Subject: Appeal of Planning Commission's Approval of Site and Development Plan Petition No. 22-40SP for the Development of a Shopping Center in the Milano PUD Located at the Southwest Corner of Laurel Road and Jacaranda Boulevard

Subject: Appeal of Planning Commission's Approval of Site and Development Plan Petition No. 22-40SP for the Development of a Shopping Center in the Milano PUD Located at the Southwest Corner of Laurel Road and Jacaranda Boulevard

SUBJECT: Safety and stormwater concerns: *Village at Laurel and Jacaranda Site and Development Plan Petition No. 22-40SP*

(R1) Proposed
Dangerous

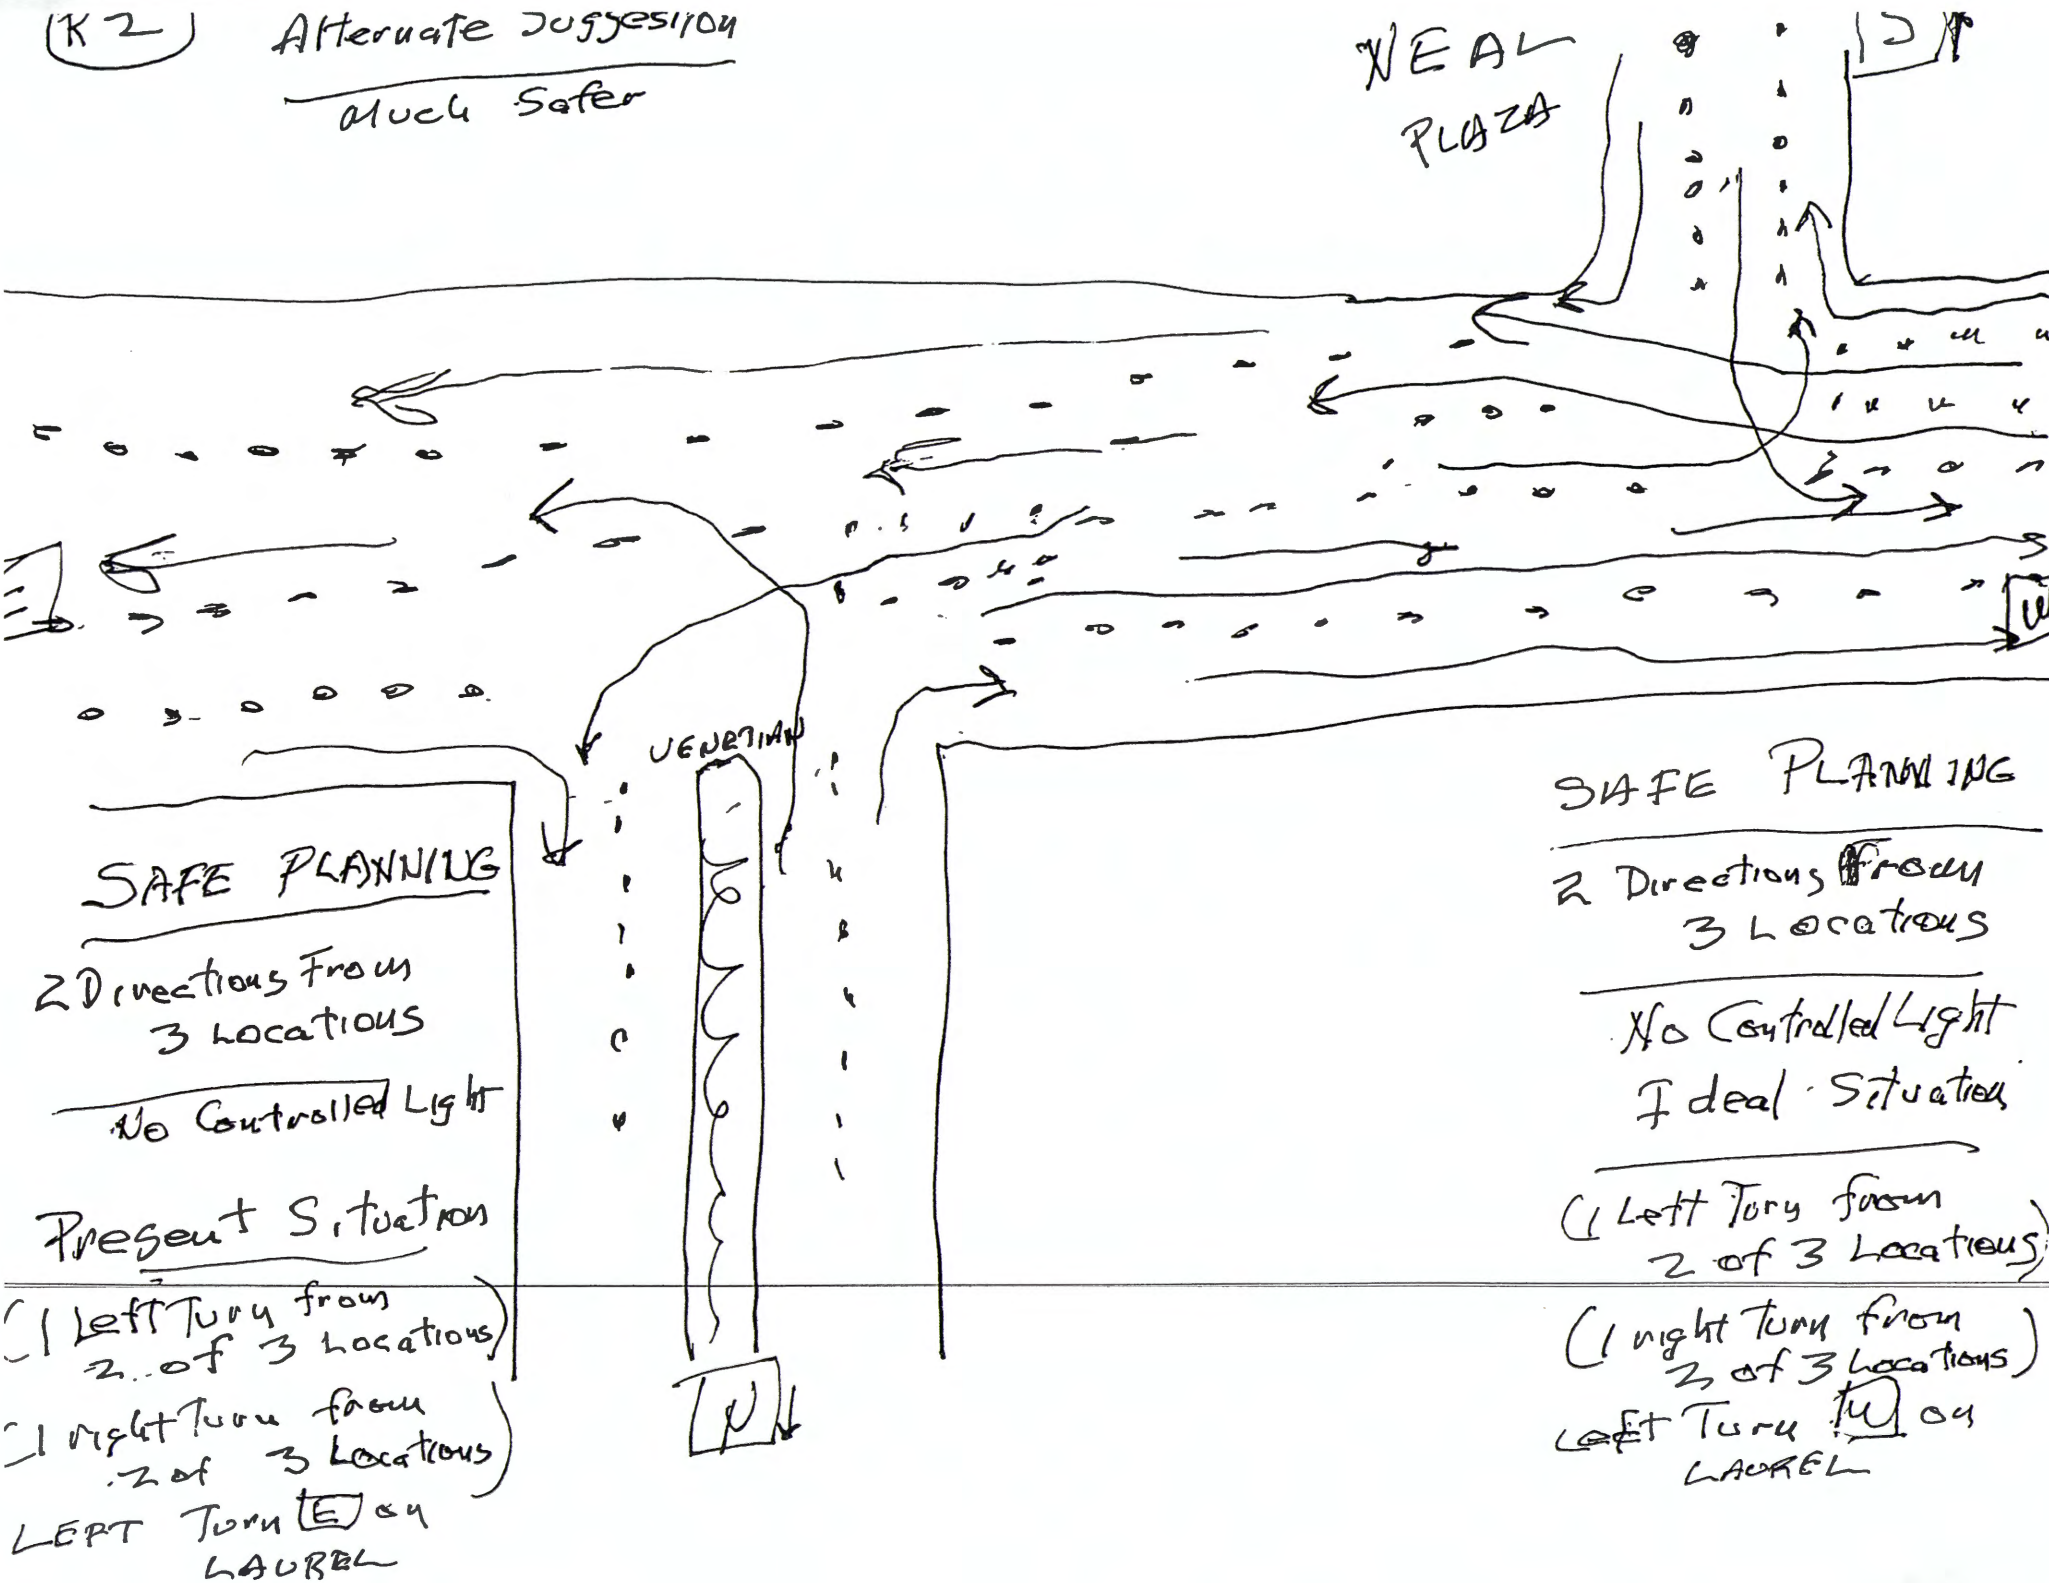
POOR PLANNING

3 Directions & ^{FROM} LOCATIONS

12 DIRECTIONS

NO controlled light

2 U Turn Situations possible reality

(2 left turn lanes on Laurel)

GOOD PLANNING
ENT LOCATED EAST
LESS THAN A
QUARTER MILE AWAY
THANK GOODNESS!!!

(K2)

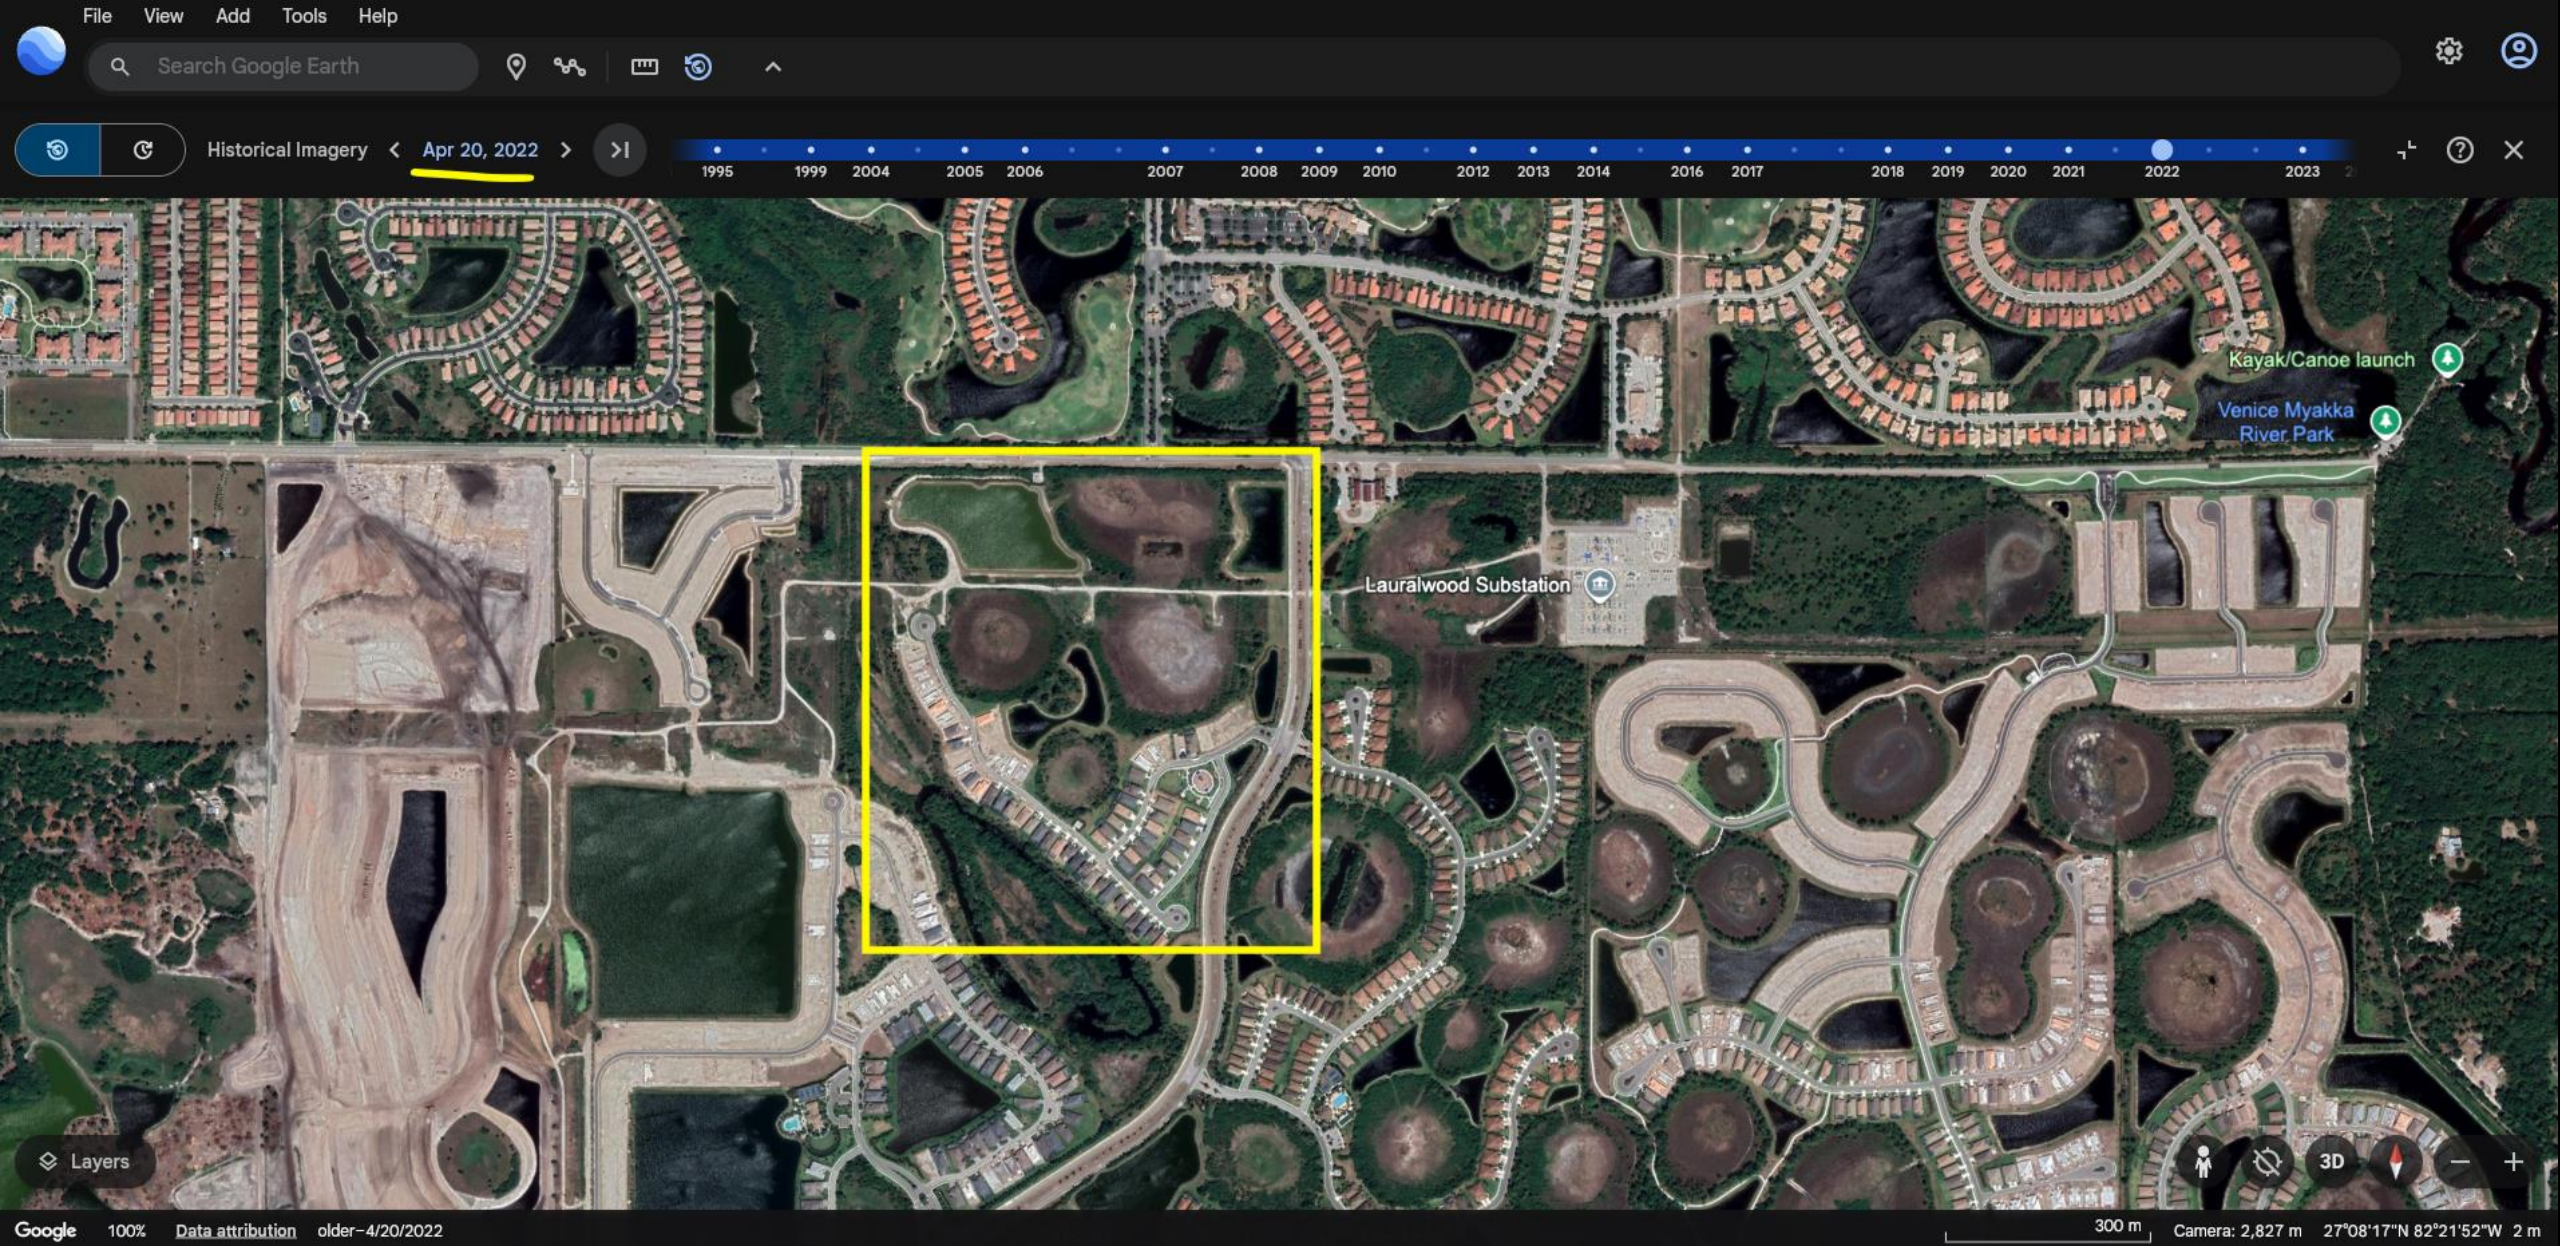
Alternate suggestion

Much Safer

SAFE PLANNING

2 Directions From
3 Locations

No Controlled Light

Present Situation

Cielo and former Cielo property 48 hours post Ian after ~18 inches of rainfall.

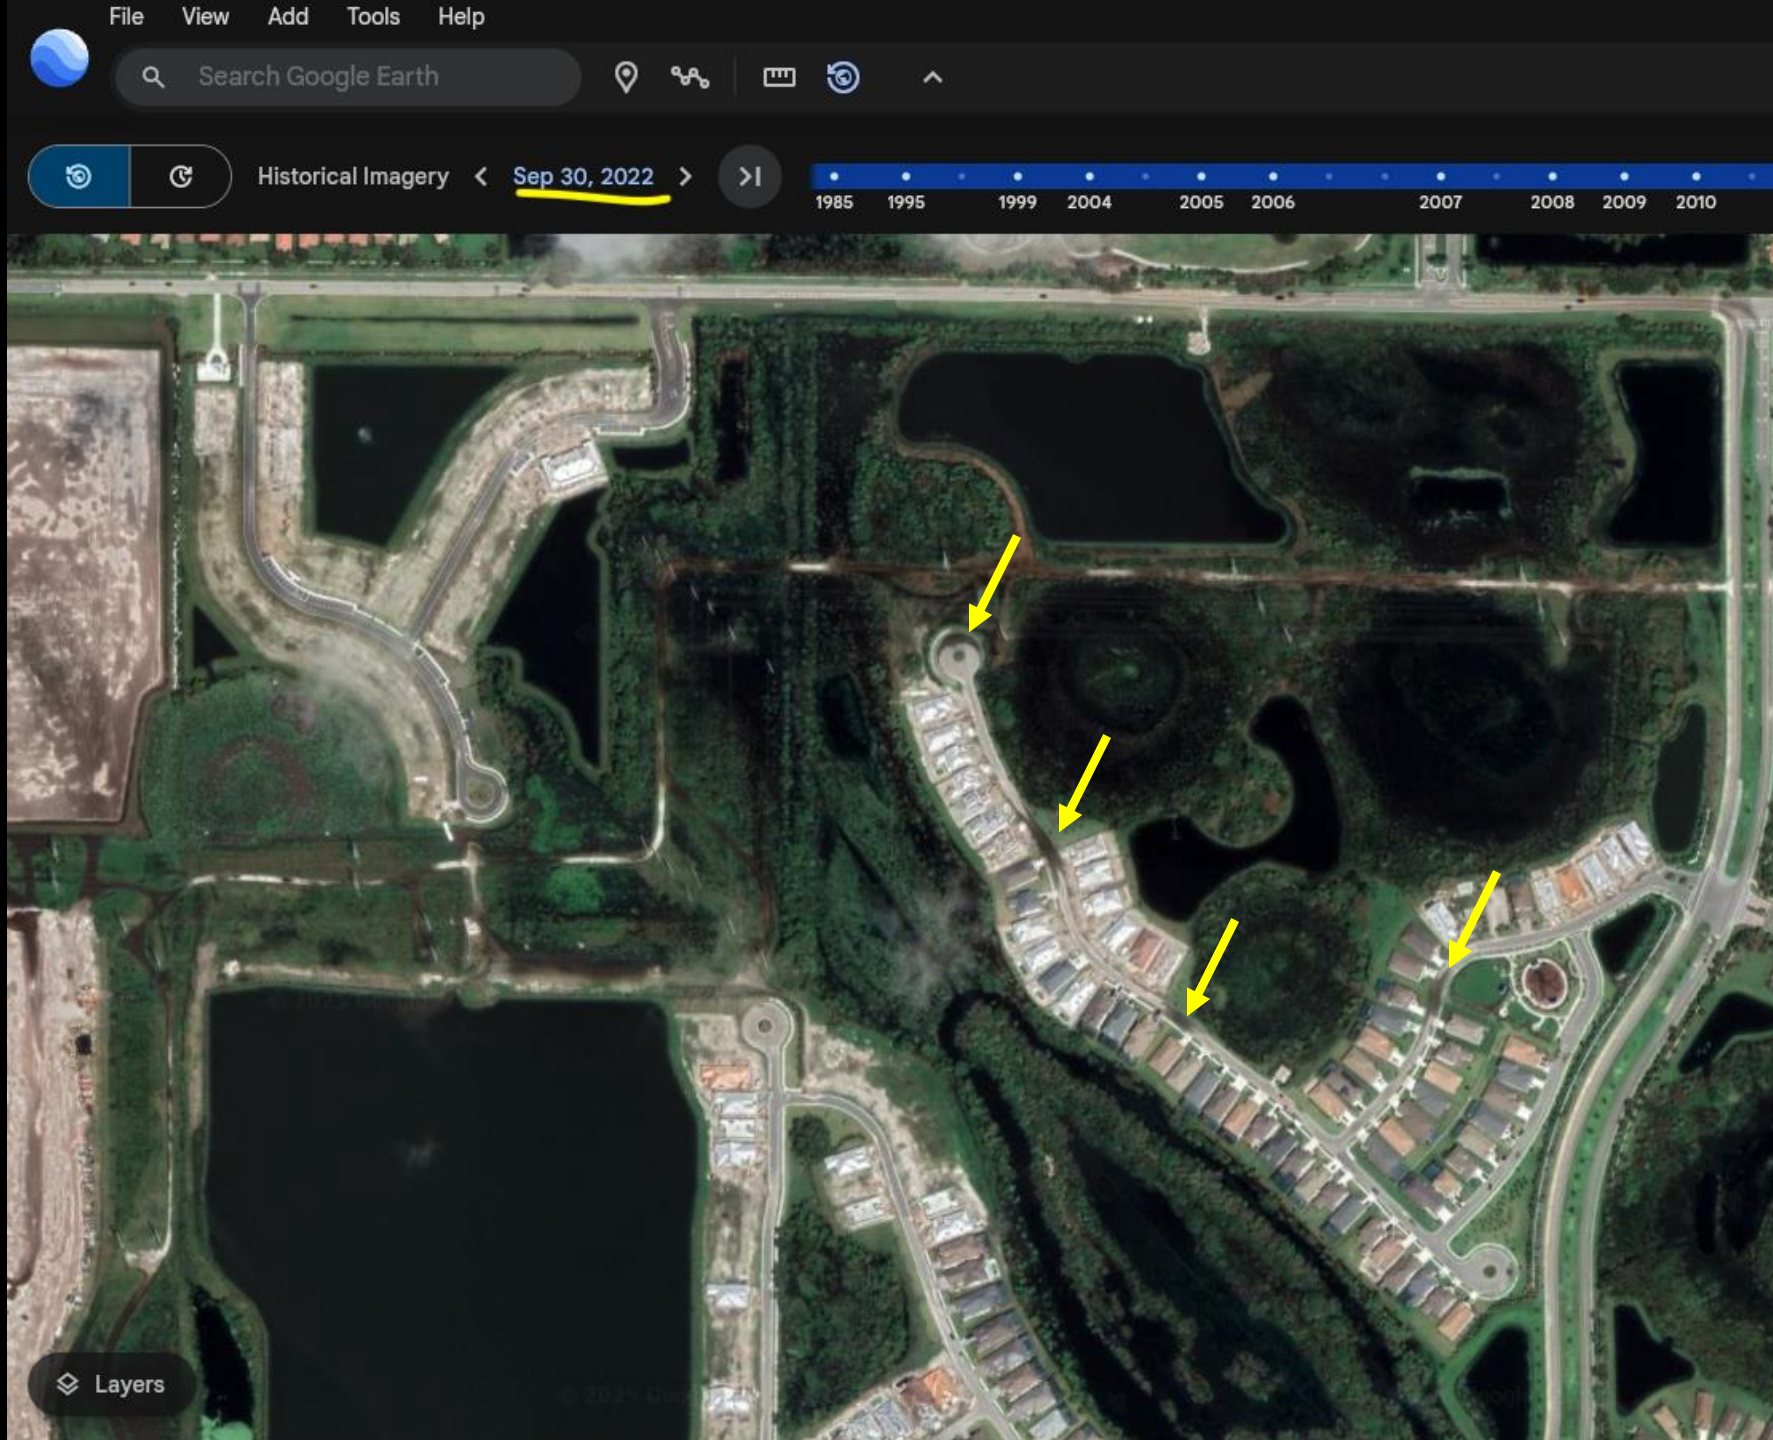
Standing, deep water 48 hours post lan. All flooded locations are where storm water management inlets are located. The inlets became outlets during and post lan.

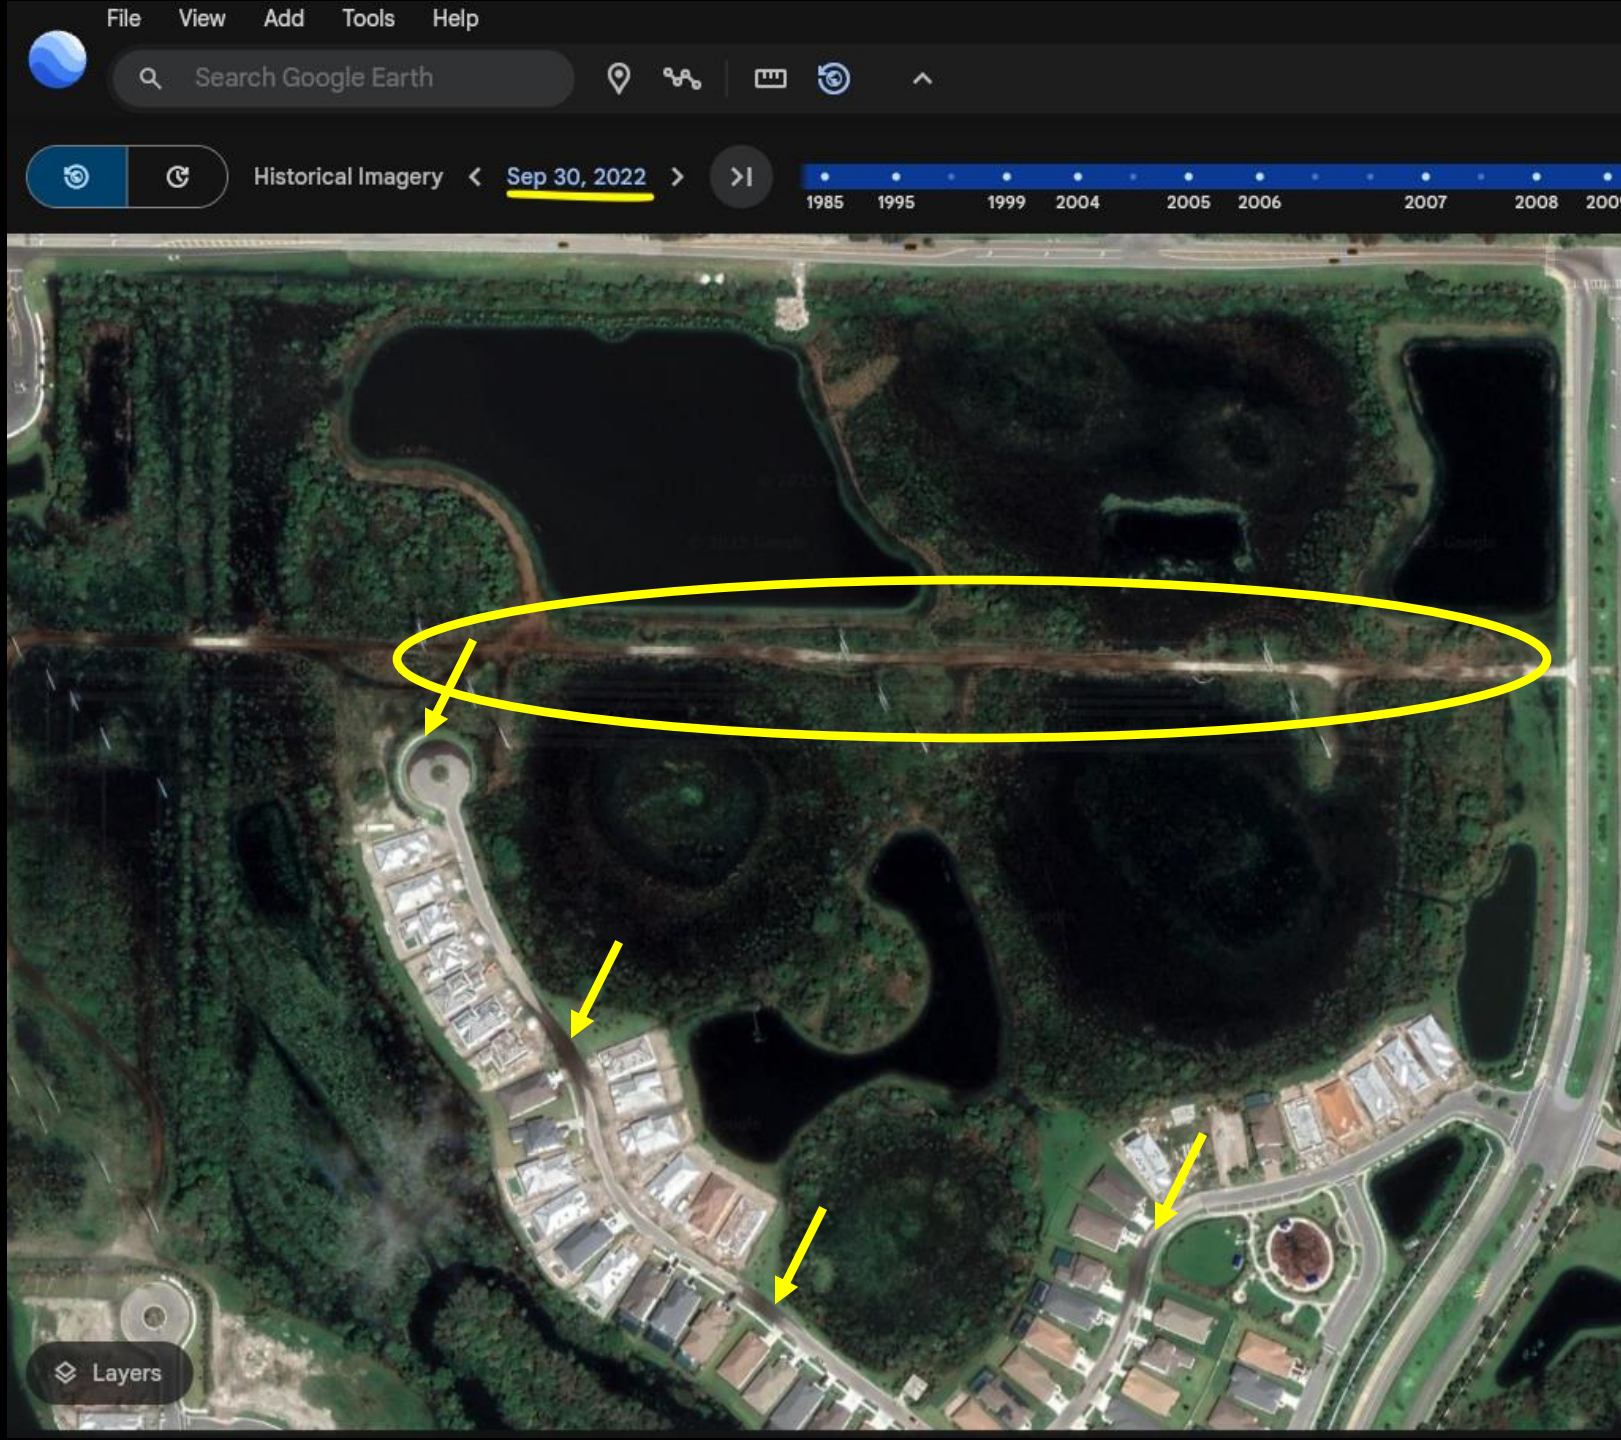
Inundation
from the pond
and wetlands
that would be
removed with
this project.
